BRUNSWICK STEAM ELECTRIC PLANT, UNIT NOS. 1 AND 2
NRC DOCKET NOS. 50-325 AND 50-324
OPERATING LICENSE NOS. DPR-71 AND DPR-62
REQUEST FOR LICENSE AMENDMENTS
ENHANCED OPTION I-A STABILITY TECHNICAL SPECIFICATIONS

MARKED-UP TECHNICAL SPECIFICATION AND BASES PAGES - UNIT 1

Figure 2.2.1-1. APRM Flow Bias Scram Relationship to Normal Operating Conditions

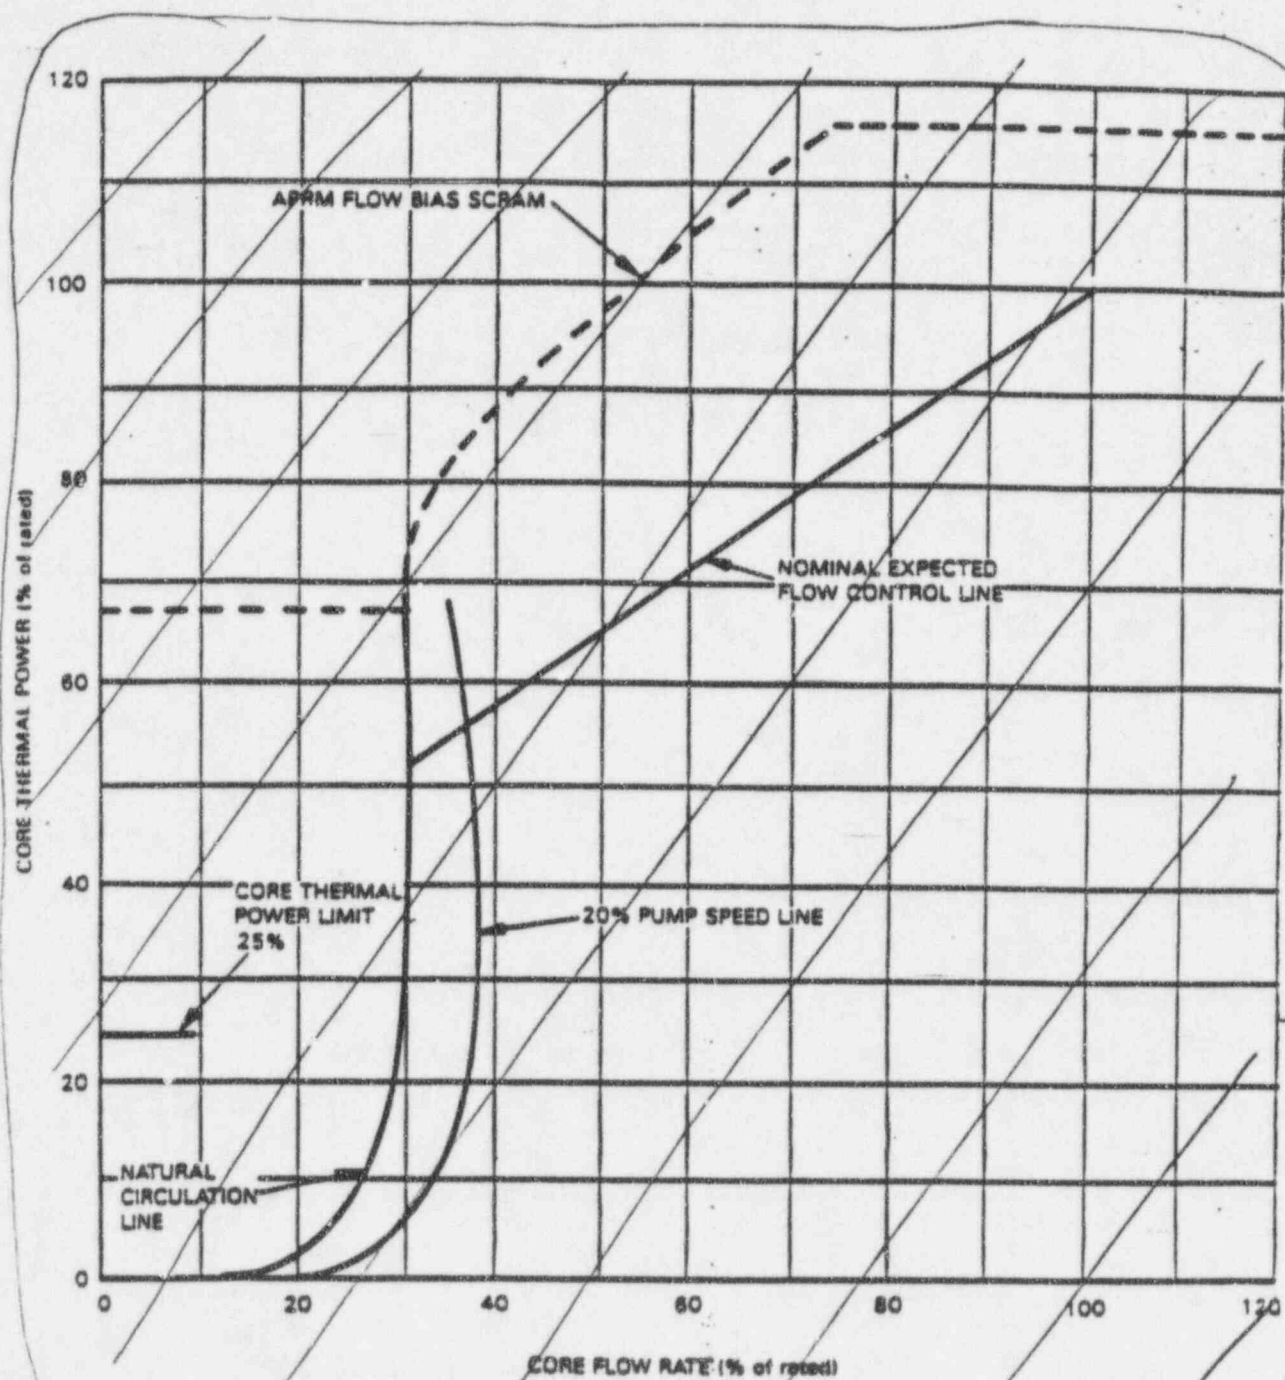
- (b) This Average Power Range Monitor scram function is a fixed point and is increased when the reactor mode switch is placed in the Run position.
- (c) The Average Power Range Monitor scram function is varied ~~Figure 2.2.1.1~~ as a function of the fraction of rated recirculation loop flow (W) in percent.

Changed per
96TSB02, ITS

FIGURE 1.1-1
THERMAL POWER LIMITATIONS

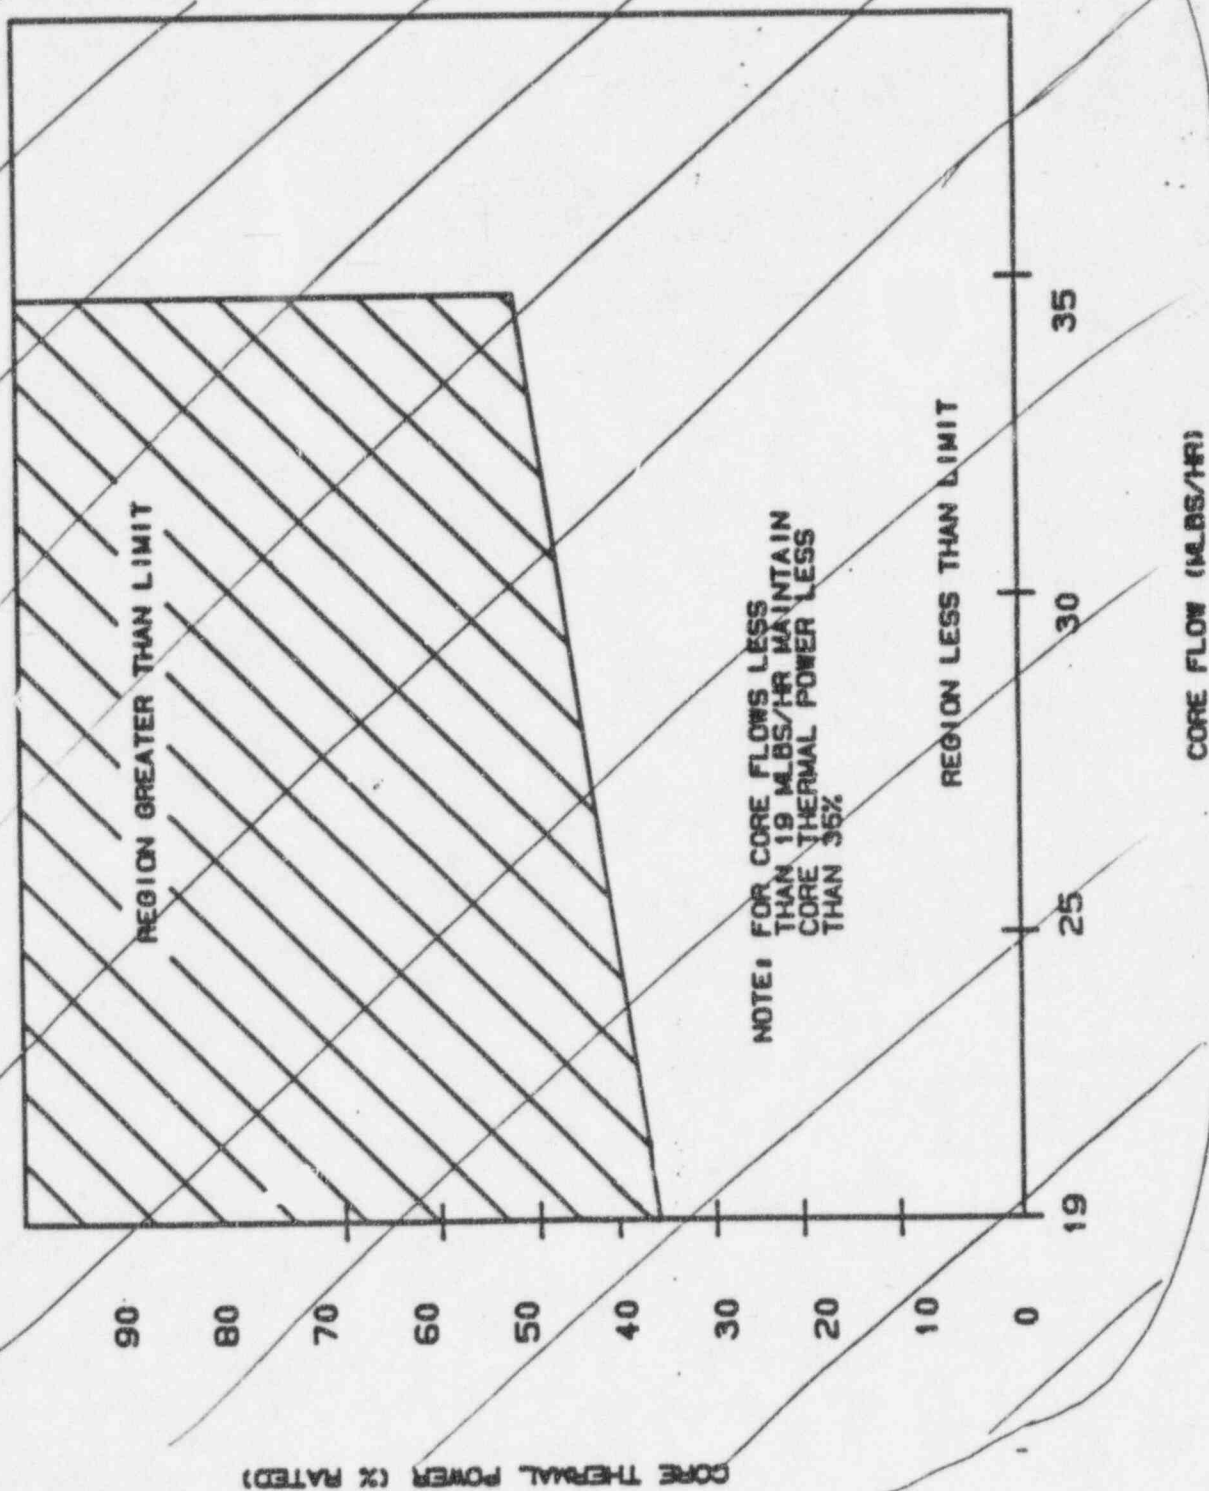
5.6.5.a.3 The Allowable Value for Function 2.6, APRM Flow Biased Simulated Thermal Power - High, for Specification 3.3.1.1; and

Figure 2.2.1-1. APRM Flow Bias Scram Relationship to Normal Operating Conditions

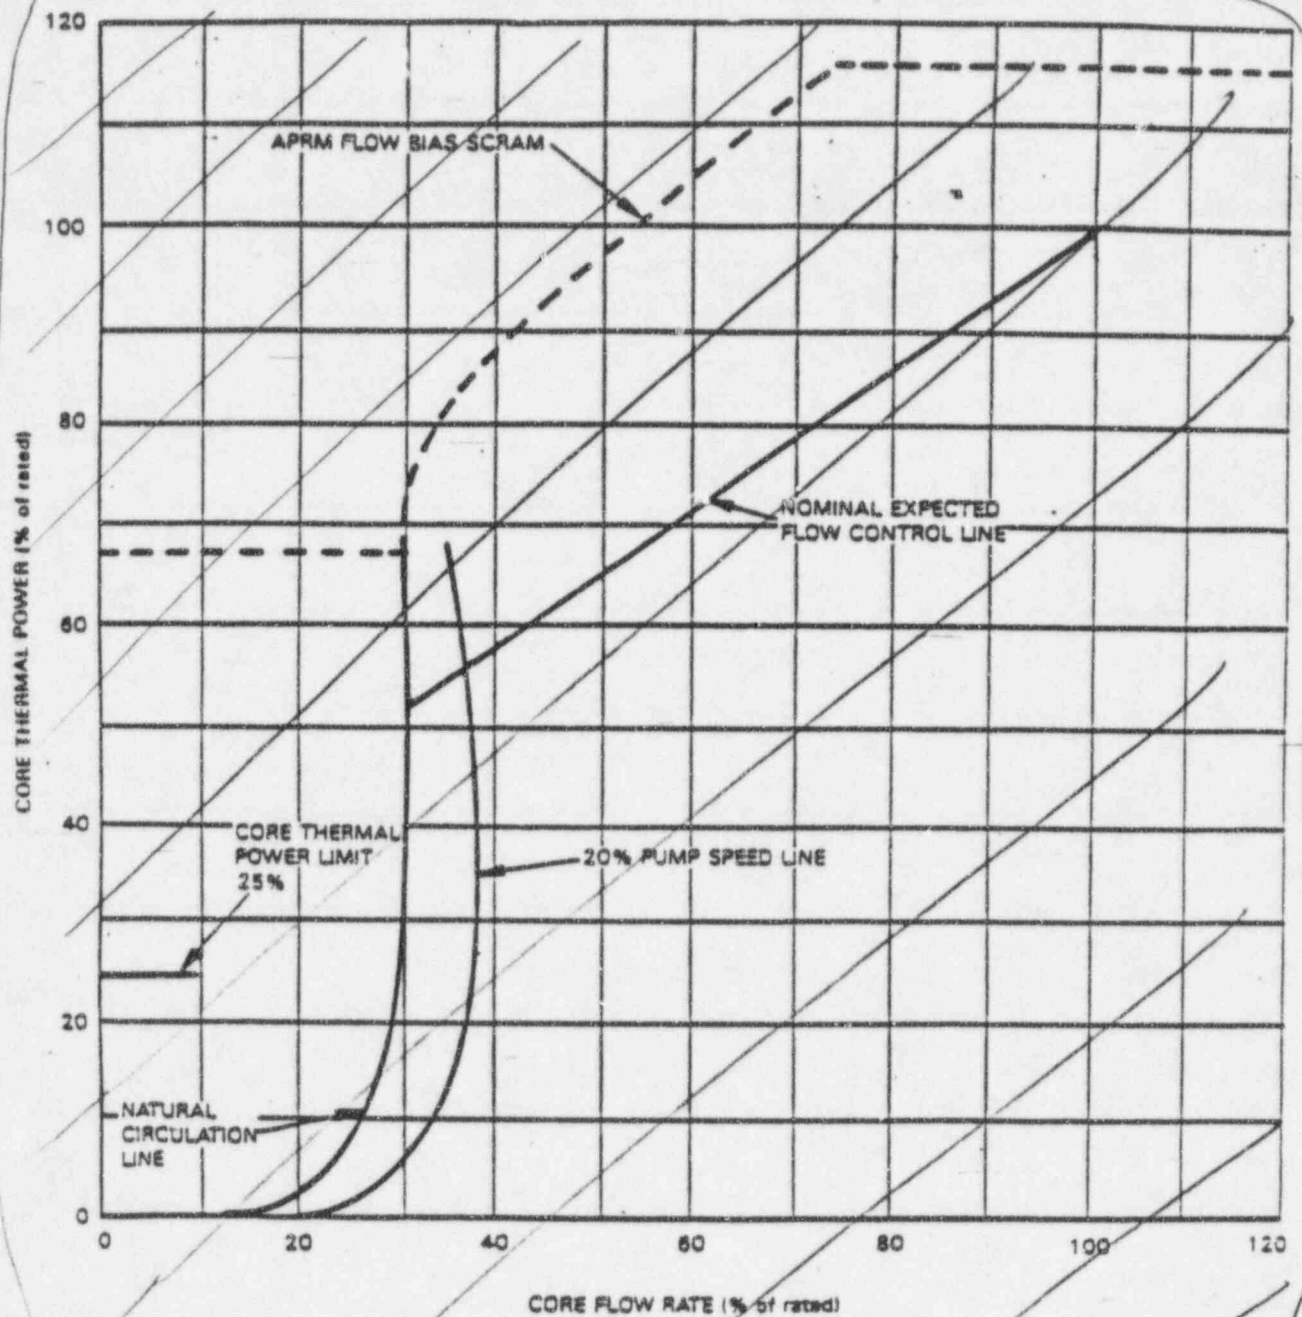
- (b) This Average Power Range Monitor scram function is a fixed point and is increased when the reactor mode switch is placed in the Run position.
- (c) The Average Power Range Monitor scram function is varied Figure 2.2.1-1 as a function of the fraction of rated recirculation loop flow (W) in percent.

Changed per
96TSB02, ITS

FIGURE 4.1-1-1
THERMAL POWER LIMITATIONS

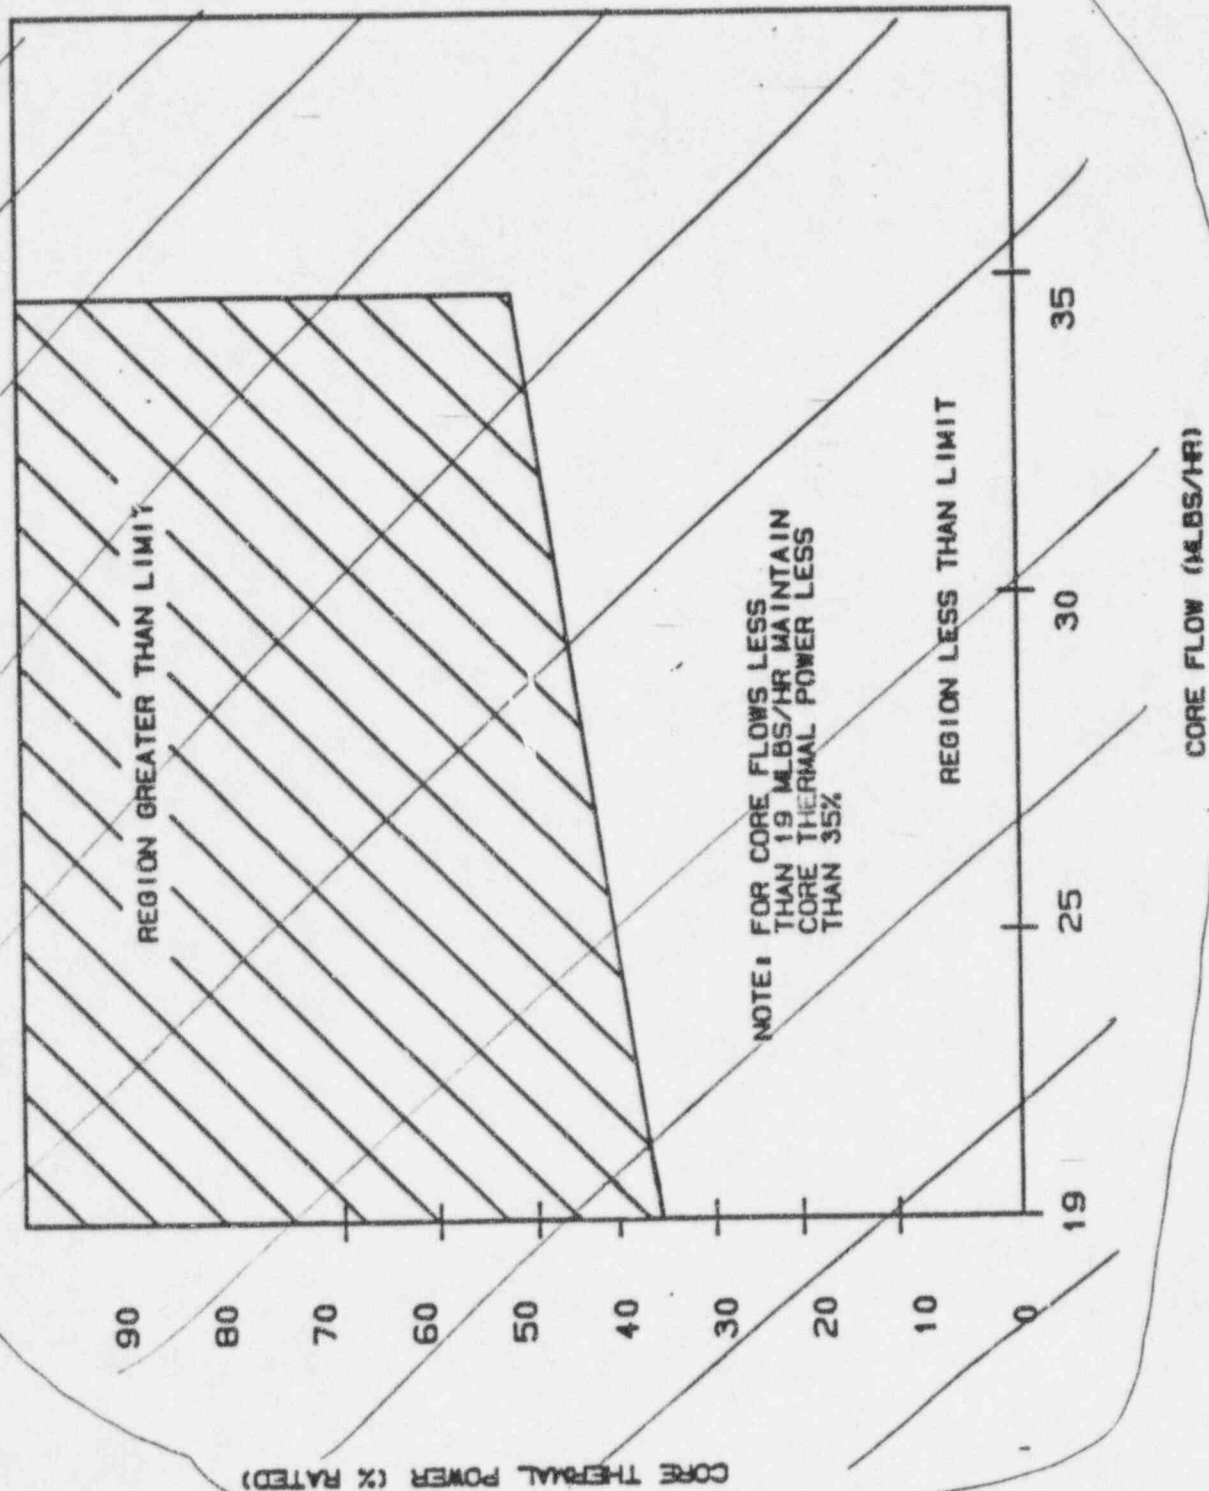
5.6.5.a.3
